DS-K1T671 Series MinMoe Terminal Release Notes (2023-06-12)

Device Model: DS-K1T671M/MF DS-K1T671TMW/TMFW	Firmware Version	ARM: ACS_671_AI3_EN_STD_V3.2.30_build230330 ACS_671_AI3_EN_NEU_V3.2.30_build230330
	Software Version	HikCentral AC: https://www.hikvision.com/en/support/download/software/hikcentral-access-control-v2-0-1/
Naming Rule: M for M1 card, W for WIFI, F for fingerprint

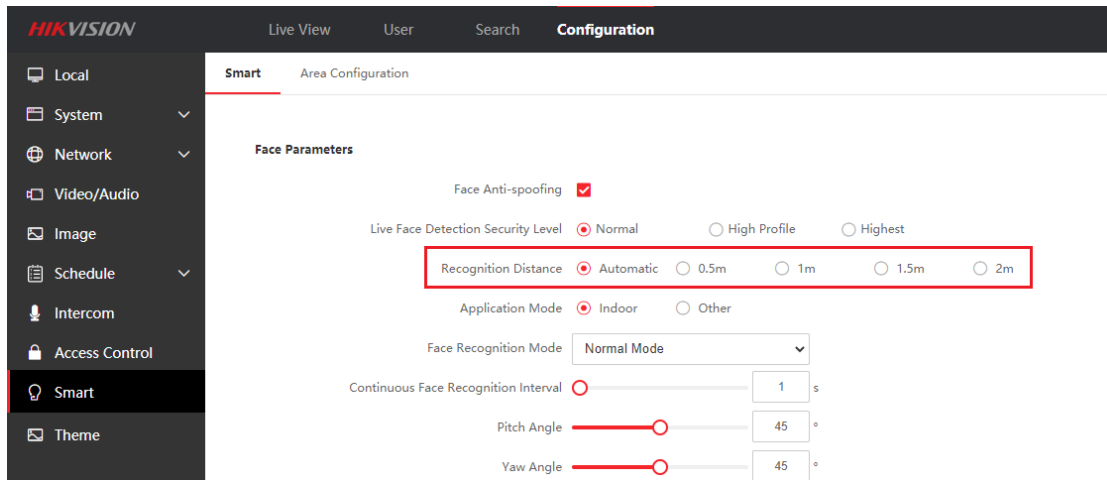
1. Add Hik-Connect menu in device UI Menu → Comm. The function is disabled in default.

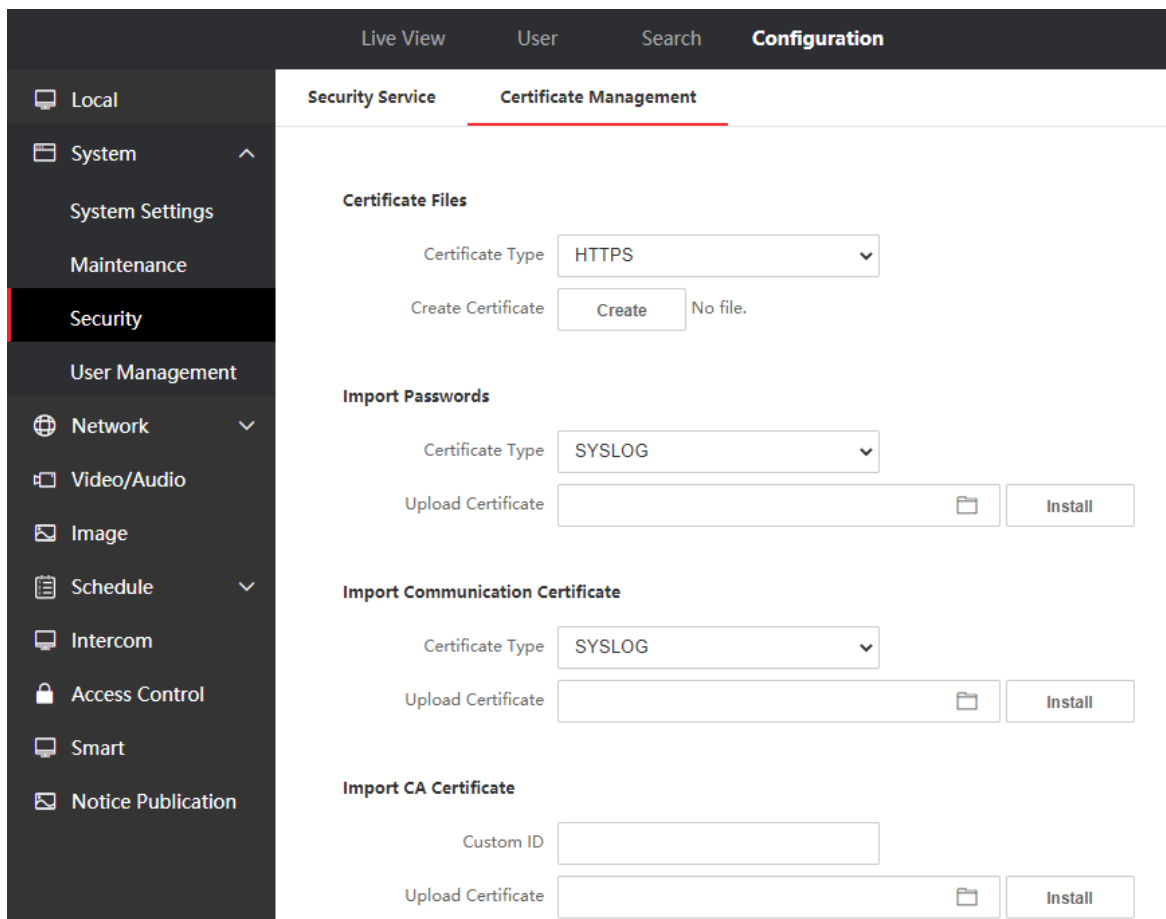
1. Support https feature

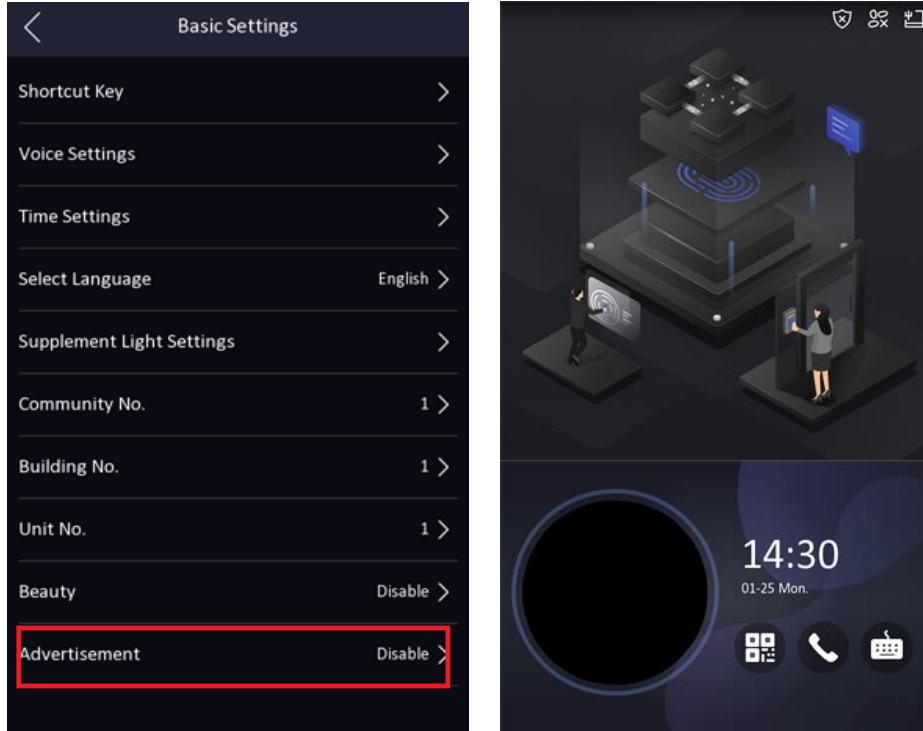
4. Add advertisement mode, after enable, the wallpaper will be fixed to be displayed on the top of main interface.

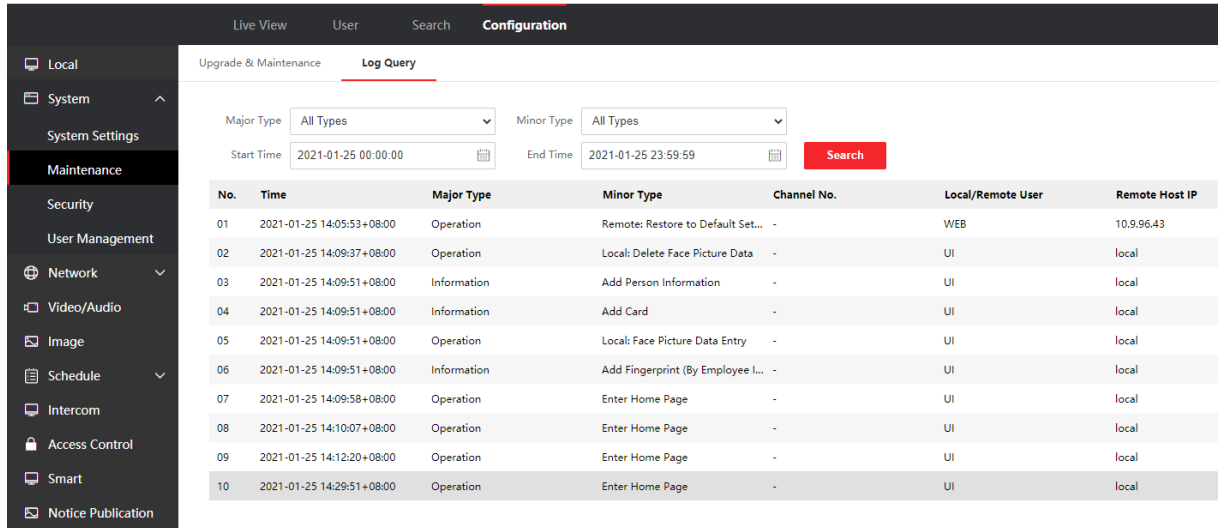
5. Add device operation log query function

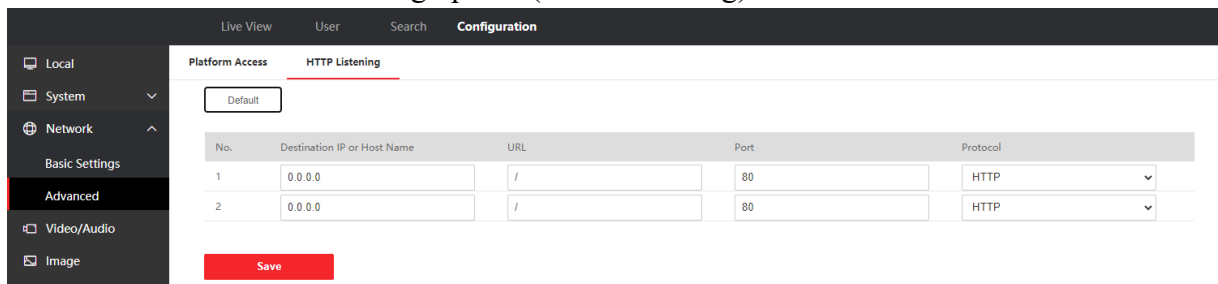
6. Add ISAPI event monitoring upload (HTTP listening) function

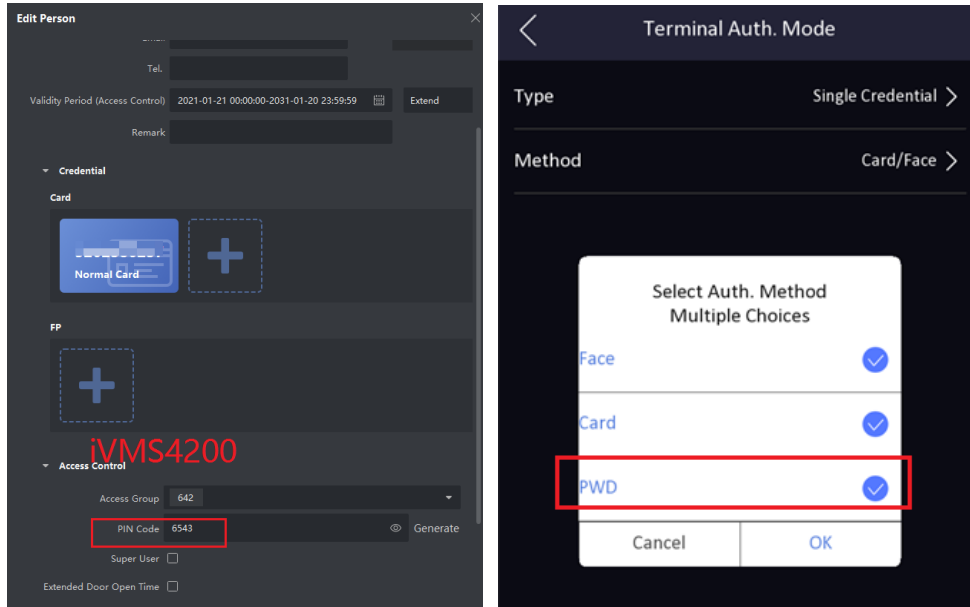
7. Support PIN code to open the door (disabled in default)

Note: PIN code should be configured from software, iVMS4200 already support, HikCentral Pro will support PIN code configuration in V2.1 expected to be released in June

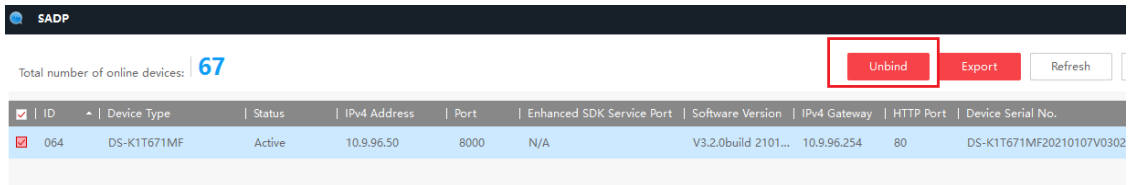
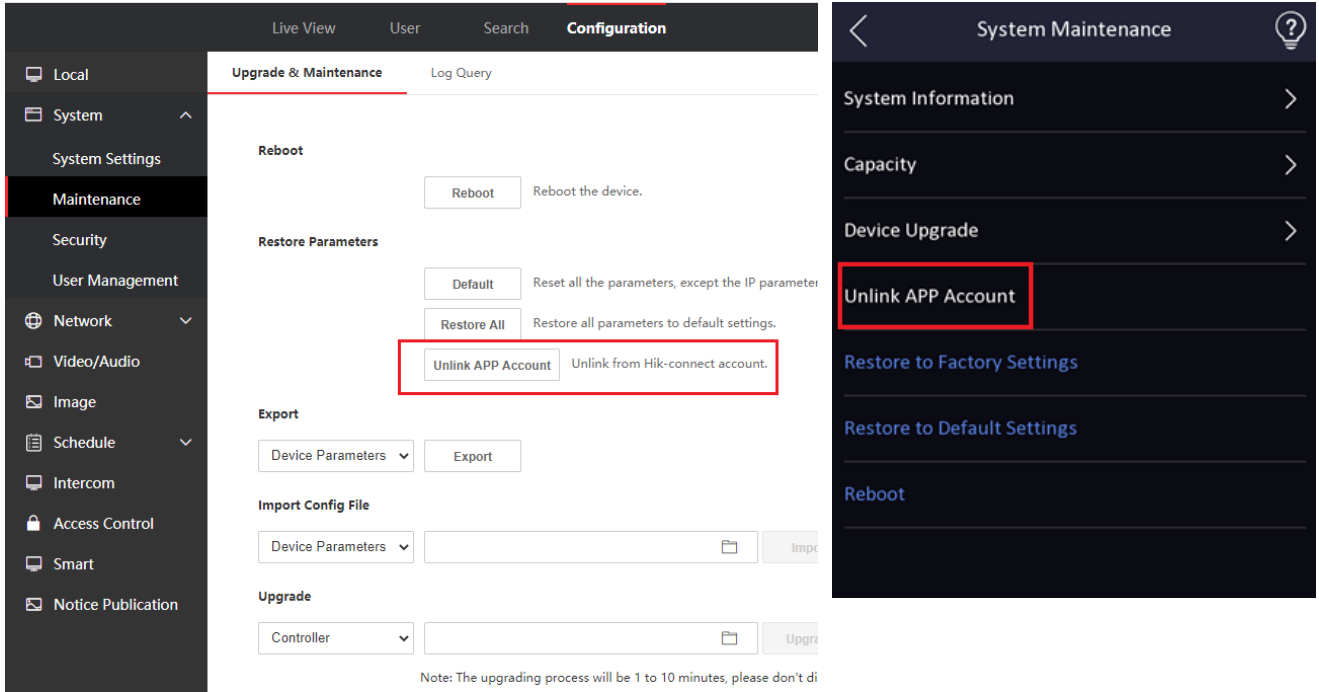
8. Support unbind device with hik-connect account on SADP tool, local UI and web interface

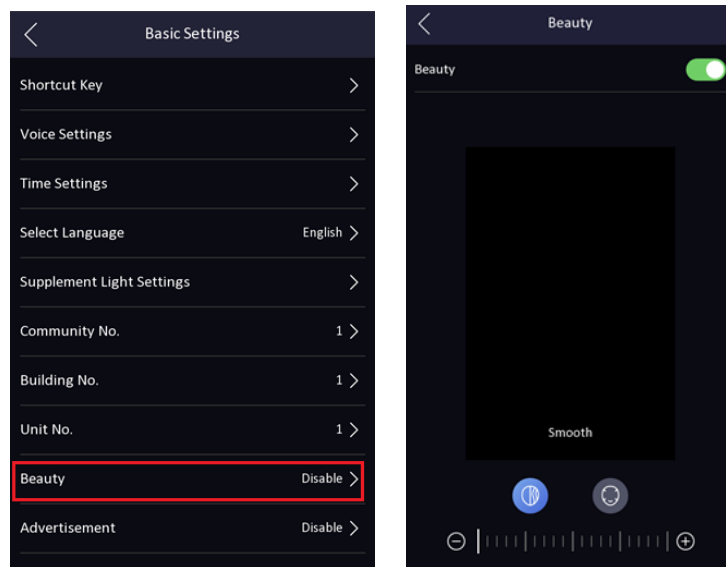
9. Add beauty function to adjust smooth and whiten parameter.

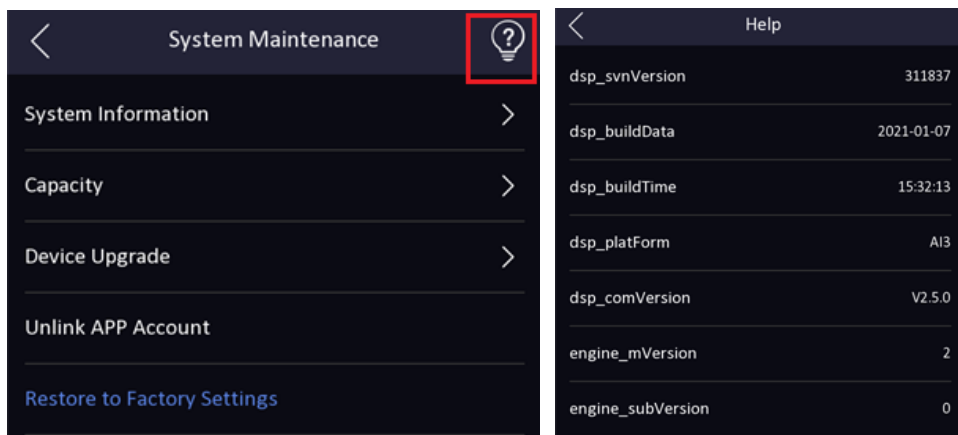
10. Add help interface to check system module version for technical support (long press for 3s).

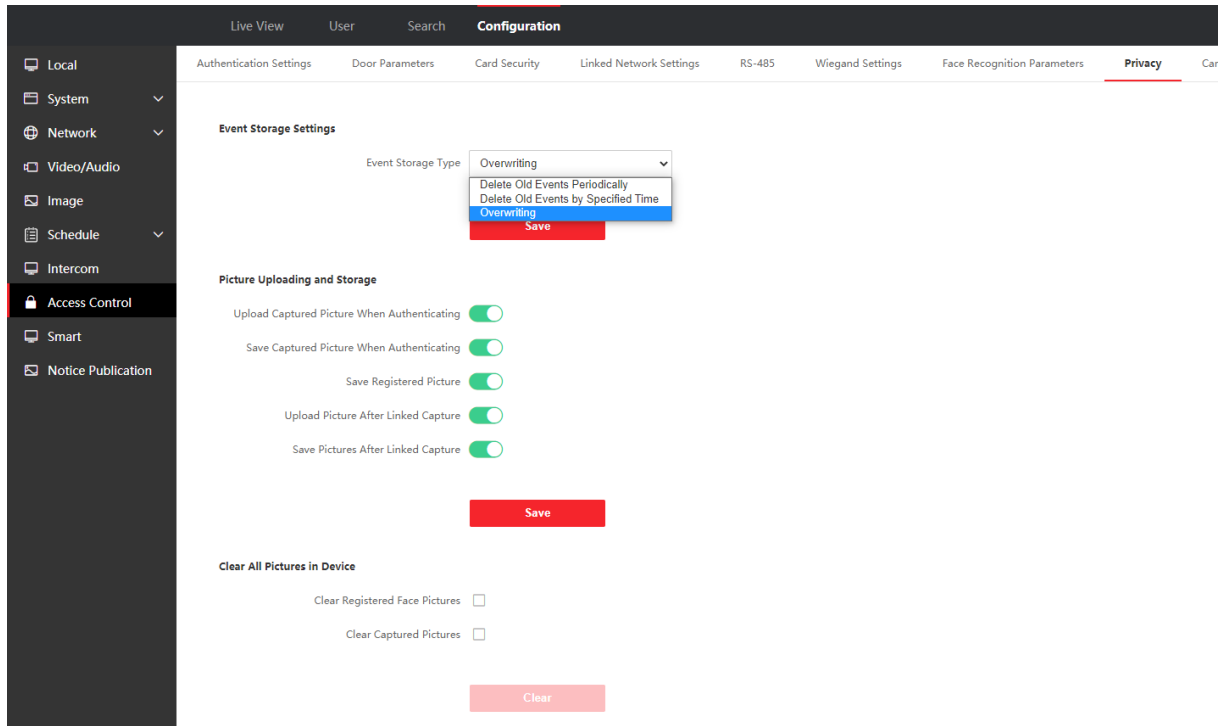
11. Add privacy protection, customer can define the privacy related parameter, such as Event Storage Settings, Picture Uploading and Storage, Clear All Pictures in Device

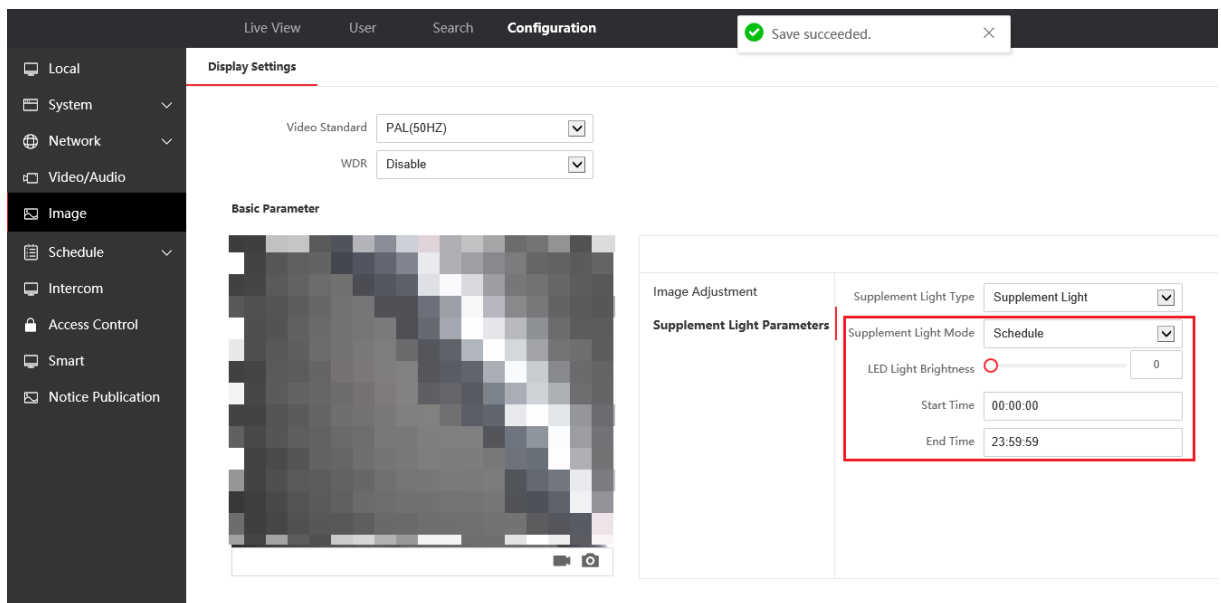
12. Configure the time period when the white light fill light is turned on and off in device local menu or web interface

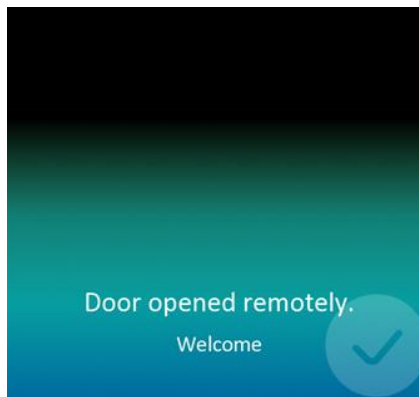
13. Add audio prompt 'The door is open' when open door on iVMS4200, HikCentral Pro, Hik-Connect App, and device UI will show prompt

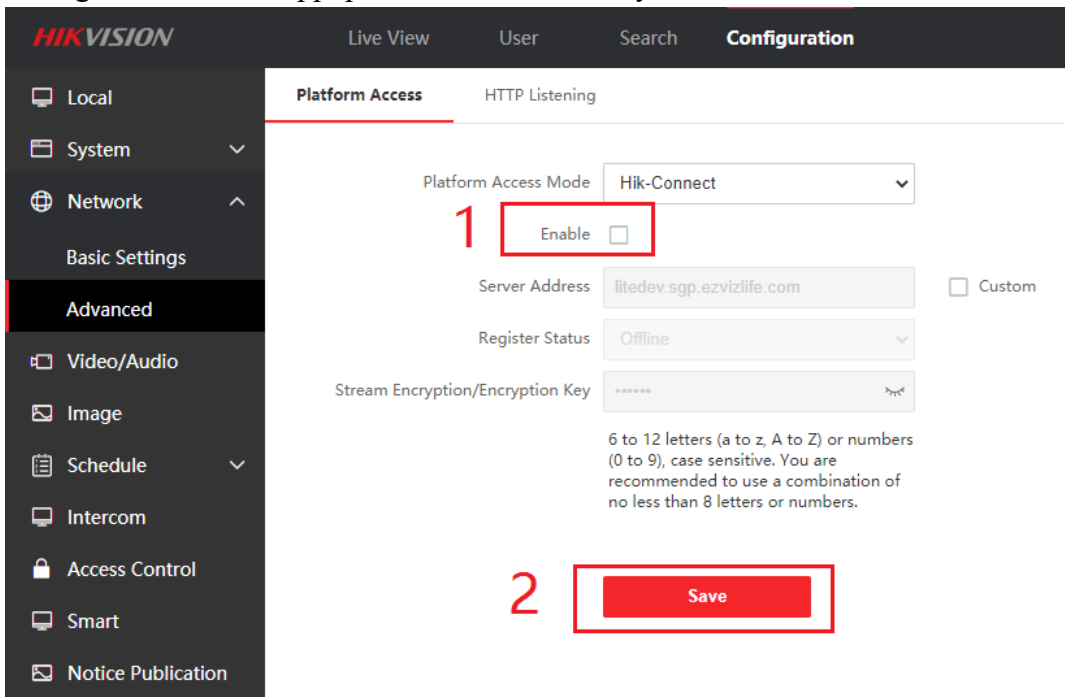
4. Hik-Connect function is turned off in default for privacy protection, if customer want to manage device from App, please turn on manually in the web.

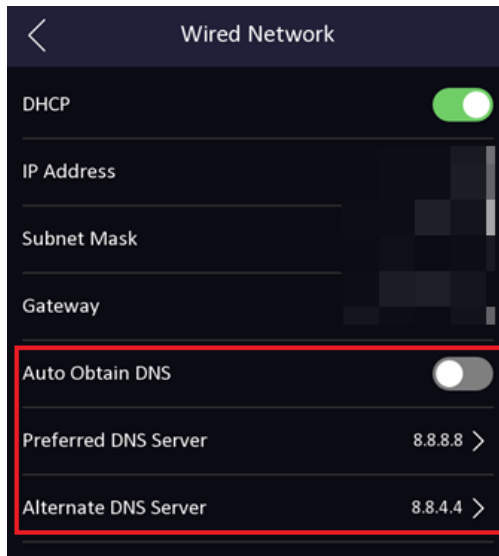
- 5. The face matching algorithm is upgraded. Improve the speed and accuracy of face recognition. Improved the recognition effect of dark masks
- 6. DNS can be configured from device UI in menu → Comm. → Wired Network

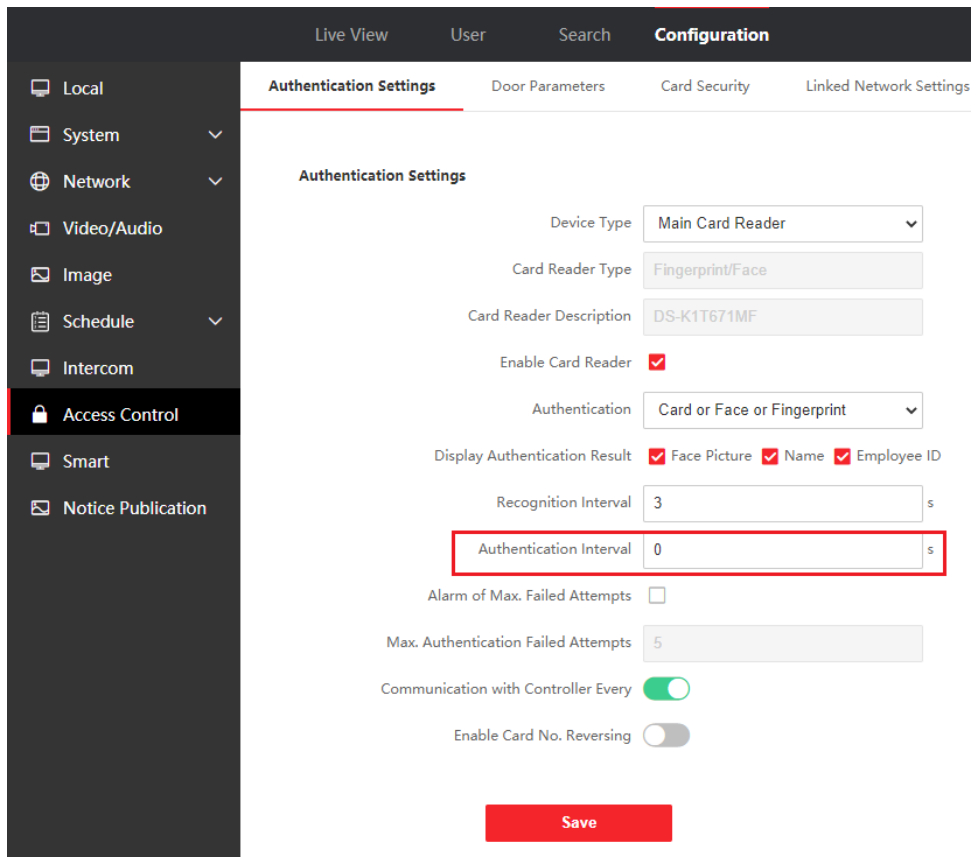
- 7. Optimized the ISUP and Hik-Connect event upload mechanism.
- 8. Add stranger authentication timeout time configuration

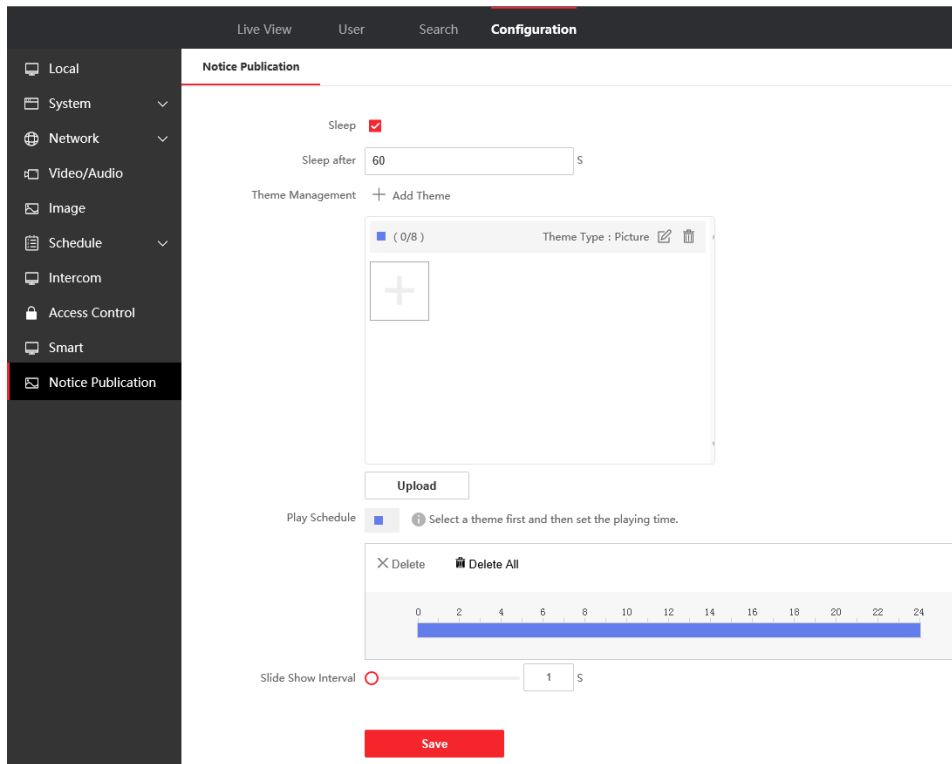
- 9. Add advertisement/wallpaper play schedule configuration, slide show interval.
